PLANNING PROPOSAL: 1 CRESCENT STREET, HOLROYD

Attachment A: TfNSW Detailed Comments on 1 Crescent Street, Holroyd

TfNSW Operational Traffic Modelling Team Review and Comments

1 Crescent Street, Holroyd Aimsun Model and Modelling Assessment Technical

Figure 1: M4 Exit Ramp queues at 8:00 am- Intersection Upgrade Scenario

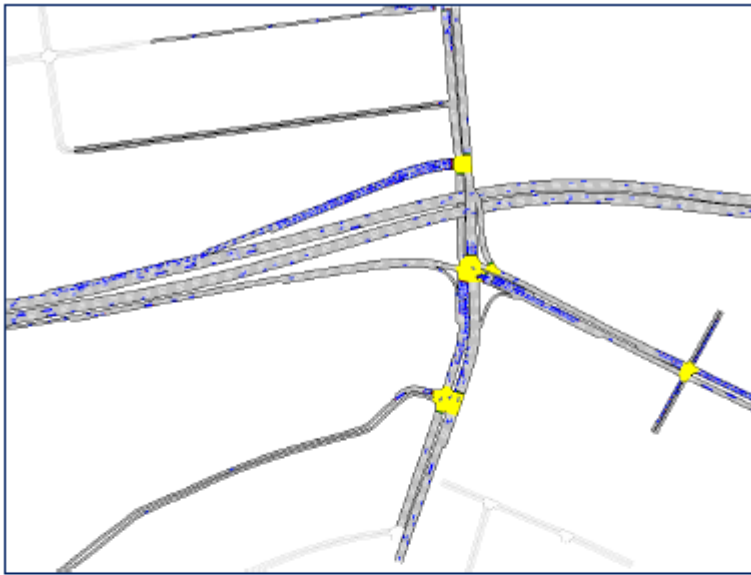
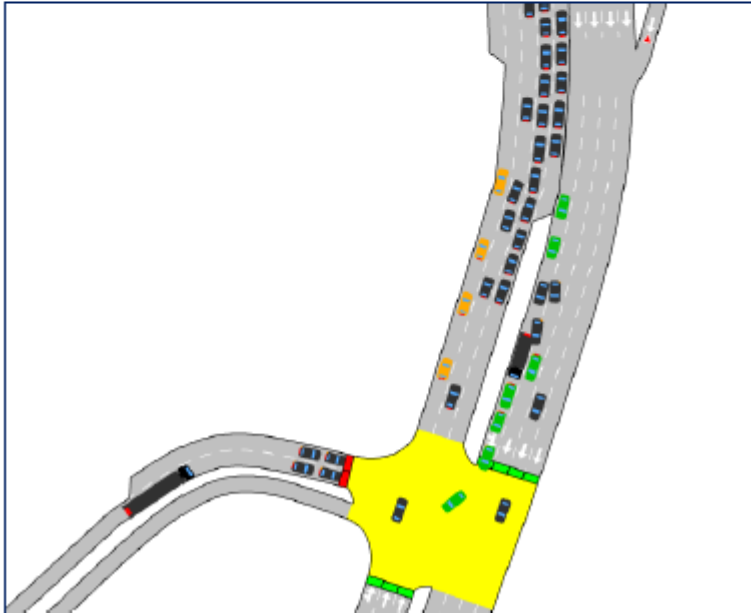
24	Network Version	Two version for this scenario have been provided. However, v2 matches what has been described in the Technical Note and hence the review has been carried out for v2.	Noted
25	Network Layout	<p>It is noted that the images provided in the technical note are not very clear. In general, the lane lengths etc. could not be reviewed. However, the number of lanes seemed consistent.</p> <p>It is therefore assumed that the correct upgrade layouts have been coded in the model.</p>	Noted
26	Signal settings	It appears that the signal timings have not been altered when compared to the Base Scenario. With additional capacity for the Intersection upgrades scenario, some minor adjustments may be warranted to phase times. As an example (Figure 1) for the AM peak hour model, queues at the M4 exit ramp are observed to reach the M4 motorway however, no congestion is observed at Church Street. Consequently, additional green time could potentially be allocated to M4 exit ramp.	Minor

Item	Section / Issue	Comment	Priority (major, medium, or minor)
		It is recommended that optimised signal timings (possibly from SIDRA) for the upgraded intersections be utilized in the microsimulation model.	
27	Model Parameters – Look ahead distance	Parameters such as look ahead distance will need to be refined at various locations throughout the model. An example is shown in Figure 2, where the turning traffic (green cars) are in the wrong lane and need to make the lane change decision much earlier. This can be achieved by altering (increasing) the look ahead distance from its default value of 50 meters. It is recommended that look ahead distances be reviewed and updated where required.	Medium
28	Model Results – Travel Time	The results reported in the Technical Note do not match the database and model observations. It has been reported in Table 7 of the Technical Note that travel time at Parramatta Road Eastbound is approximately 50 minutes whereas the model run (seed 28) indicates the maximum travel time of approximately 16 minutes within the AM peak period. In conjunction with comment 20, it appears that there was an error in calculation of travel times. It is recommended that travel times be reviewed and updated accordingly in the Response Letter and the Technical Note.	Major
